Metro Inner Development Assessment Panel Agenda

- 3.1 Lot 2 (No. 454) Murray Street, Perth - Proposed 7 level mixed-use development containing 68 tourist and visitor accommodation units and a ground floor café – DAP/26/03083

RESPONSIBLE AUTHORITY REPORT – FORM 1	
DAP Name:	Metro Inner DAP
DAP File No:	DAP/26/03083
LG Reference:	DAP-2026/5068
Proposed Development:	Proposed 7 level mixed-use development containing 68 tourist and visitor accommodation units and a ground floor cafe
Value of Development:	\$10 million
Owner:	Rich Peace Pty Ltd
Applicant:	Urbanista Town Planning
Local Government Area:	City of Perth
Responsible Authority:	City of Perth
Authorising Officer:	Julia Kingsbury, General Manager Planning and Sustainability
Application Acceptance Date:	25 March 2026

RESPONSE TO REQUEST FOR FURTHER INFORMATION

MILIGAN STREET

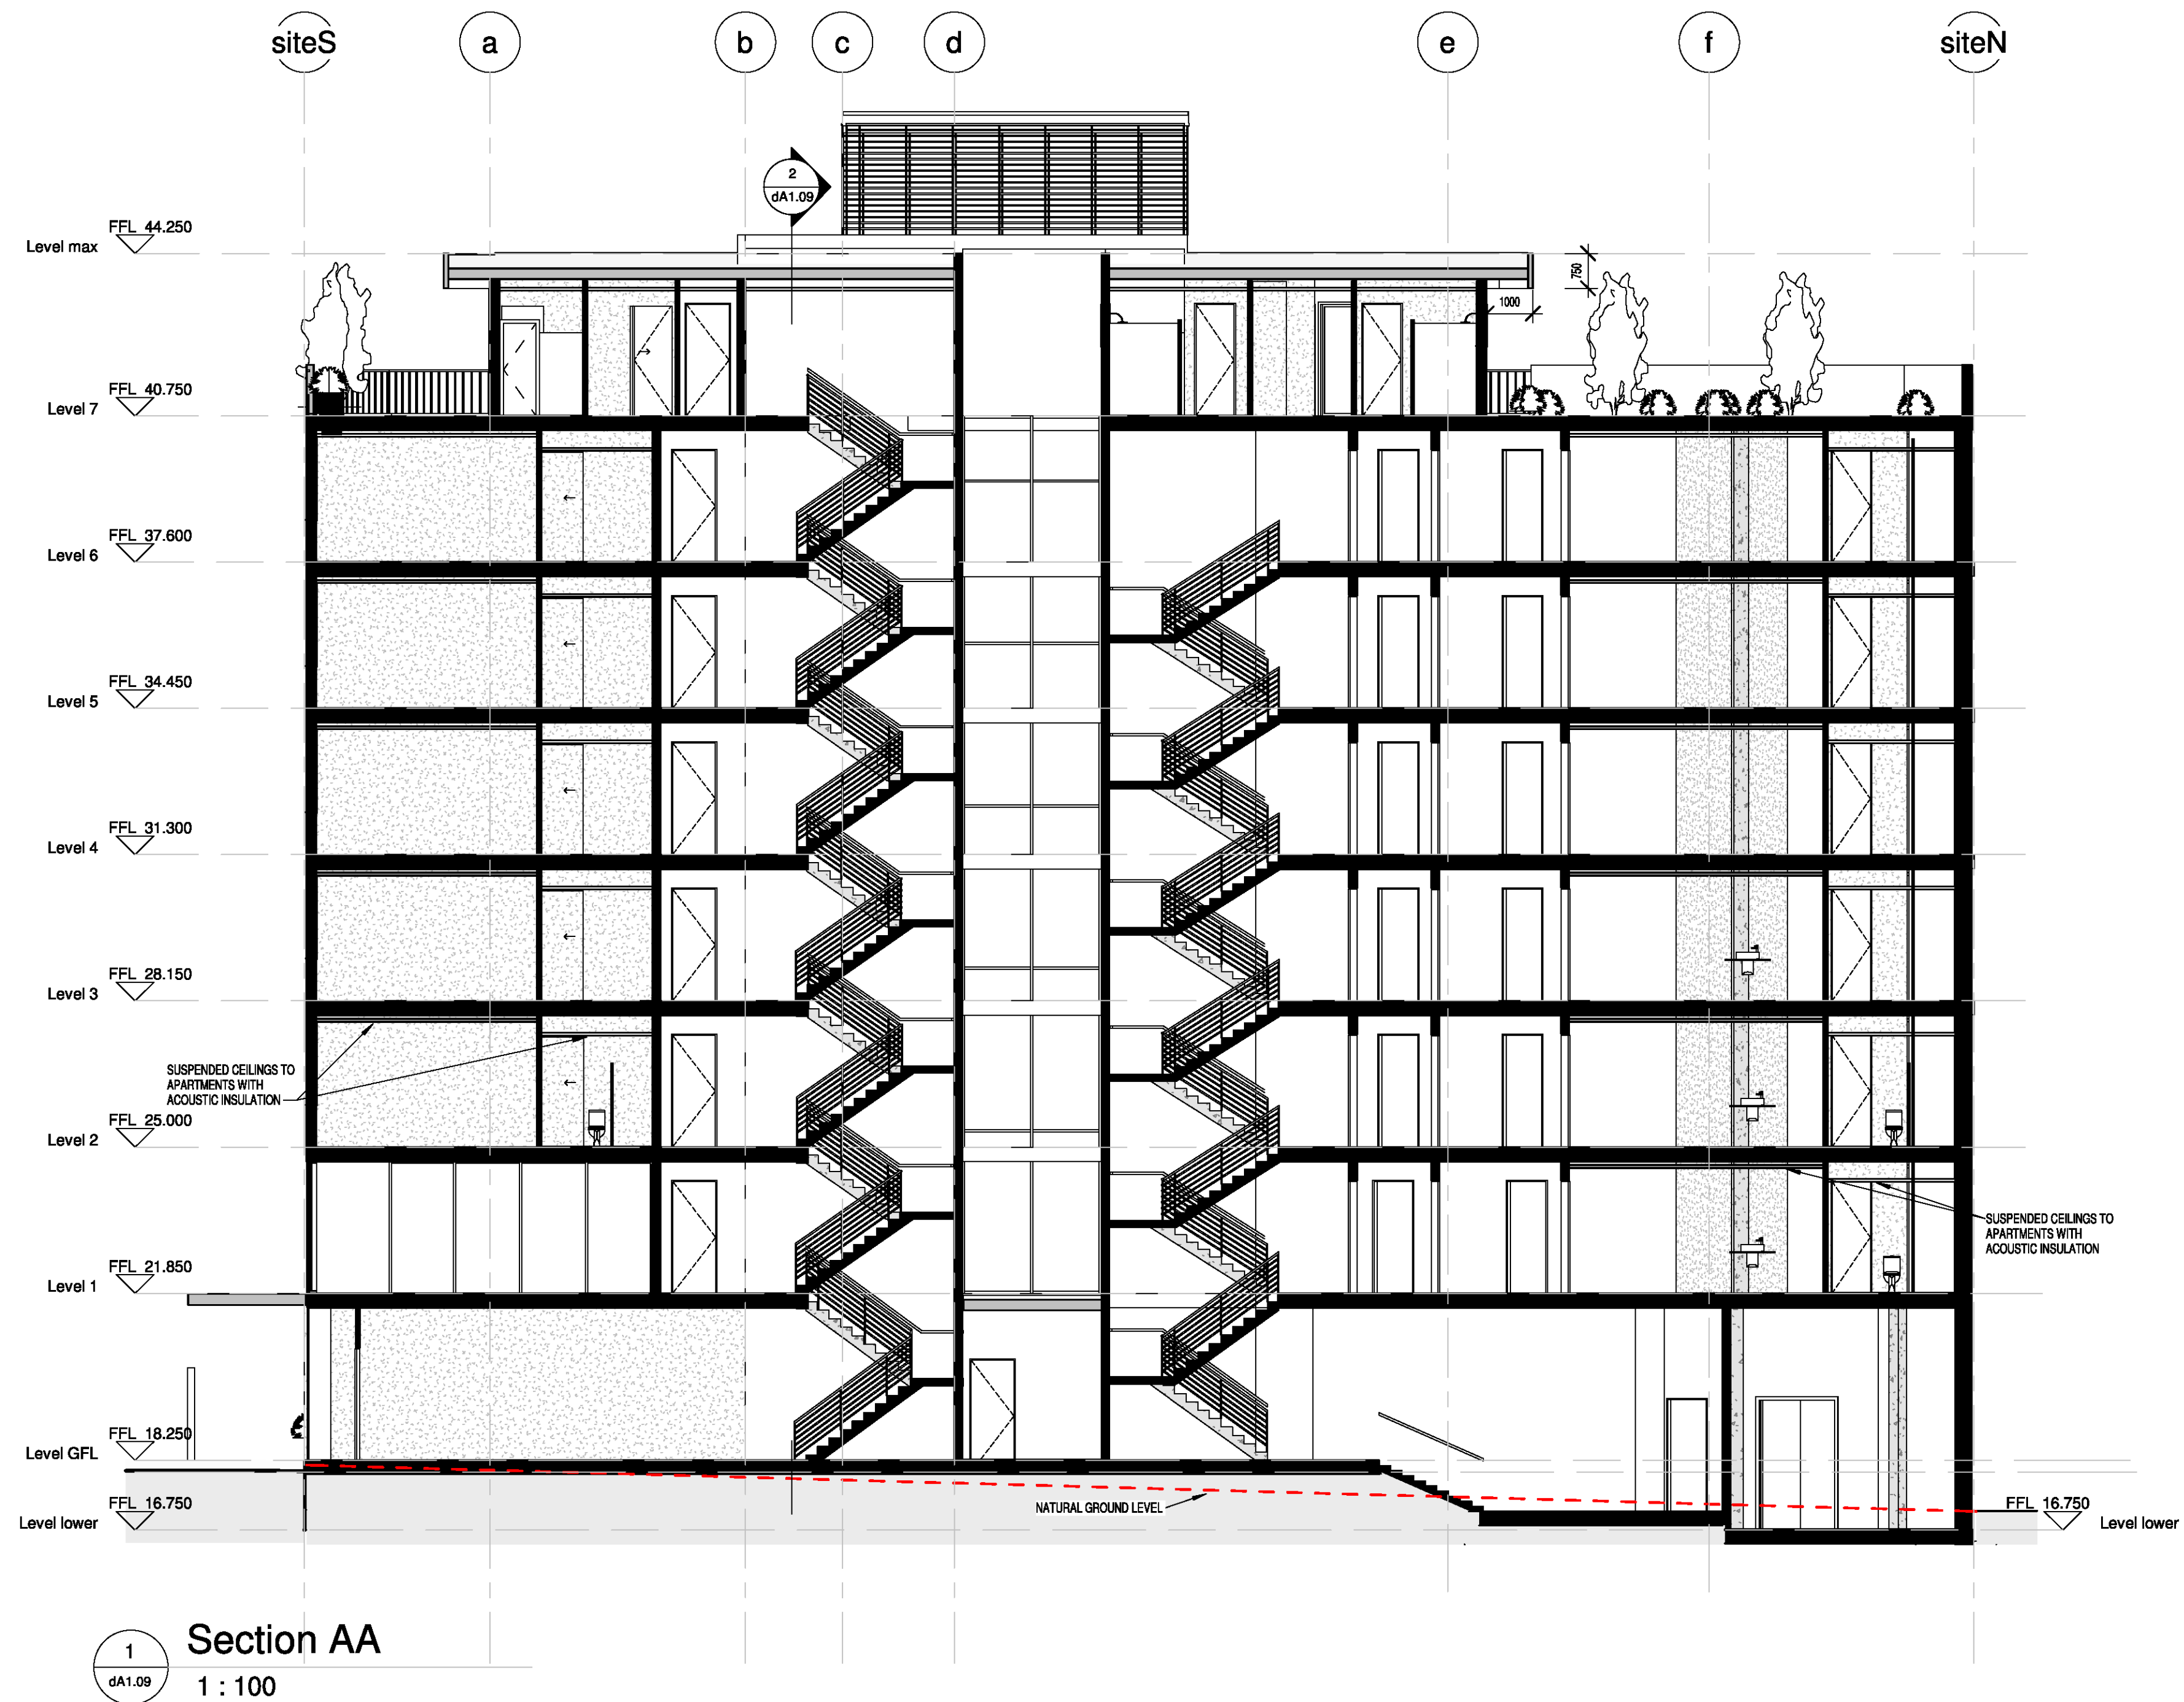
City's Comments	Applicant Response
• Ensure the screen on the Milligan St elevation and any other architectural features attached to the building do not encroach more than 250mm into the public realm. • Review the northern elevation – it adjoins a lot boundary, but the building (a balcony) appears to be built up to the property boundary. Consider whether it could possibly be built up against. • Consider providing justification for elements of the proposal that do not meet the relevant CPS2 development requirements – maximum building height, setbacks of upper building levels, rear (north) setbacks and bicycle parking.	• The plans have been amended showing no architectural features encroaching more than 250mm. • Additional planning justification for building height, setbacks and bicycle parking is provided below. • It is noted that the City previously requested justification for plot ratio, however this was assessed to be compliant.

- Canopy should be dashed on floor plan.
- Location of A/C condensers illustrated on plans.
- Show natural ground level (NGL) dashed on elevation plans.
- Show outline of neighbouring buildings dashed on elevation plans.
- Show suspended ceilings in wet areas.
- Show full extent of overshadowing as it appears cut off.
- Show overshadowing at 10am, noon and 2pm on the 22nd of August, 22nd September and 22nd October as per the Major DA kit.
- Ensure the 3D imagery and elevation plans are consistent (i.e. window arrangements, architectural features and services).
- Show all existing street trees, furniture, light poles etc on the plans.

- The canopy is shown dashed on the floor plan.
- A/C condensers shown on the roof plan.
- The NGL is shown on the elevation plans.
- Neighbouring buildings are shown dashed and also in the updated perspectives.
- Suspended ceiling shown in wet areas.
- Full extent of overshadowing shown, along with the times of day requested.
- 3D perspectives are consistent.
- Street trees, furniture and light poles are shown on the plans.
